PHILADELPHIA ELECTRIC COMPANY

Subject: Limerick Generating Station, Units 1 & 2
Information for Containment Systems Branch Regarding
Primary Containment Isolation Valves,
FSAR Table 6.2-17

Attached are draft changes to FSAR Table 6.2-17 regarding primary
containment isolation provisions to ensure that valve isolation signal
nomenclature is in agreement with the proposed Limerick Technical
Specifications. This change was discussed in the referenced telecon.

TABLE 6.2-17

Pg 11 of 20
left hand
side

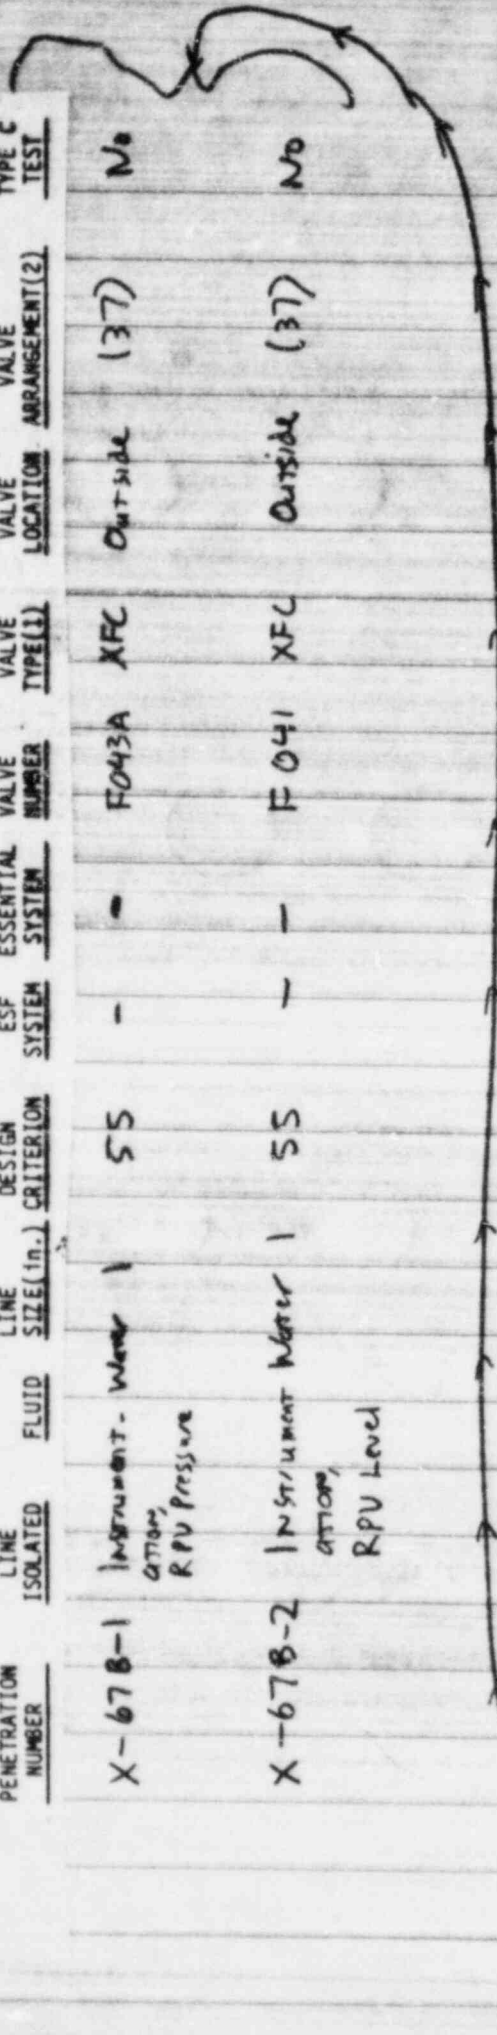
INSERT new pens X-67-B-1 & X-67-B-2 from attached sheet.

Insert at bottom of Pg 11 of 20
